APPENDIX I

Comments and Comment Responses Received After Publication of the Draft Environmental Assessment

Email 13-8

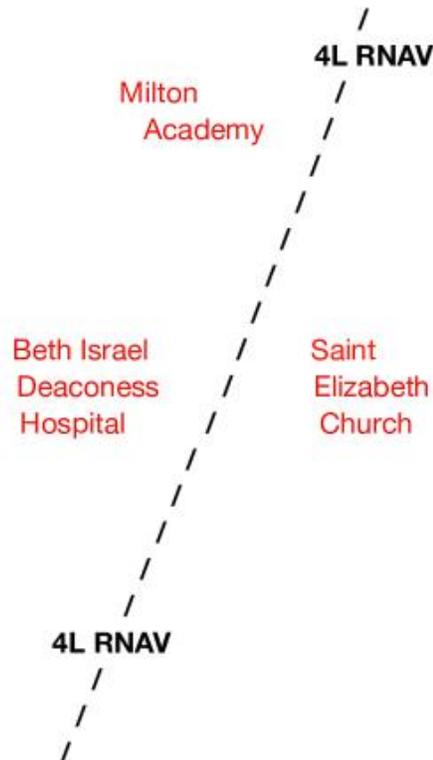
6. See the attached diagram illustrating that based on the Draft 4L EA Visualization the proposed 4L RNAV path will overfly the triangular areas formed by three noise sensitive areas, namely hospital center, church and rectory, and a 13-year school campus. In light of this, provide the Nabove 25 Lmax peak day 60/50 [day/night] noise measurement, and corresponding DNL measurement, for each of those three locations.

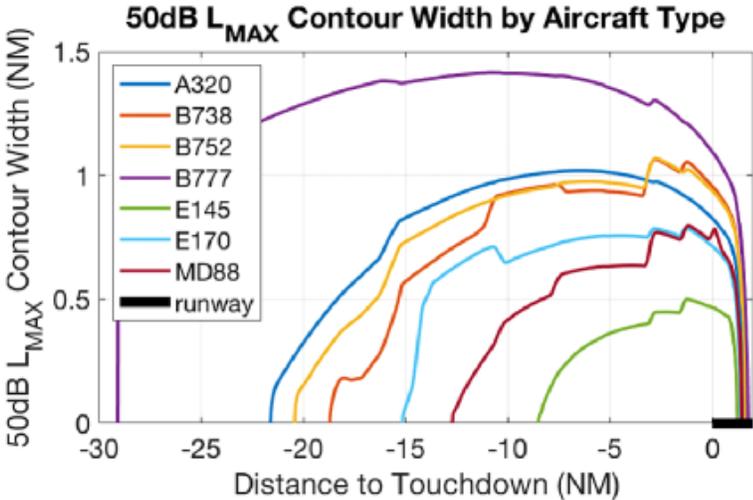
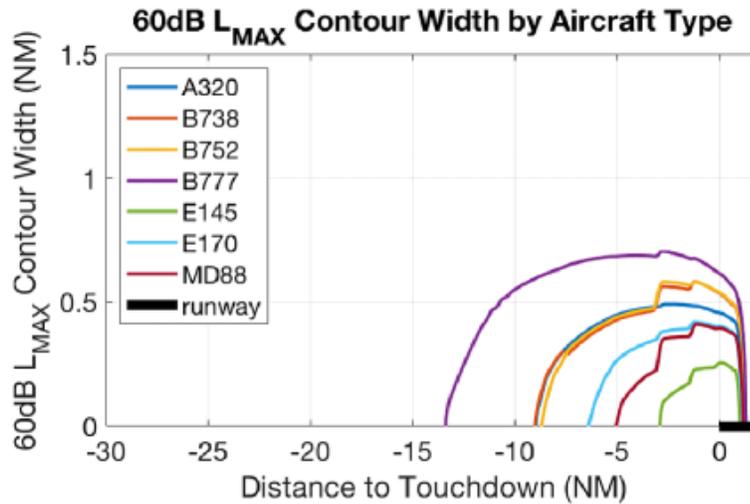
1. that planes proceeding along the 4L path create so-called **noise contours** that reach to the west and east side of each plane; and
2. by doing so, they extend 4L noise to the west of the path and 4R noise to its east; but also by extending 4L noise to the east toward the 4R path, and 4R noise to the west toward the 4L path create a **noise overlap** between the 4L and 4R paths increasing noise occurrence, intensity and duration in that between-CSPRs overflight area.

MIT identified aircraft noise contours as part of its work on the Massport-FAA study referred to earlier in these Comments. The following MIT diagram shows that from distances 15 nautical miles and less to touchdown many aircraft (each identified by type) generate noise contours of

Figure 2 – Contribution to the overall noise emission of a typical long-range jet airplane during the landing phase

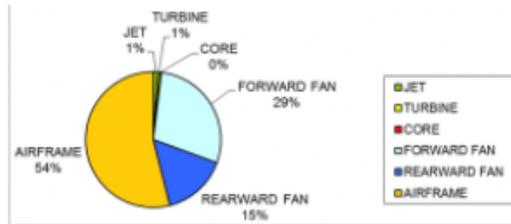
For a typical long-range airplane during the approach phase, around 54% of the noise stems from the airframe. Out of these 54%, 76% originate from the landing gear alone (see Figure 2 and Figure 3).

In total, the landing gear accounts for about 40% of the total noise emissions of a long-range airplane in approach conditions.
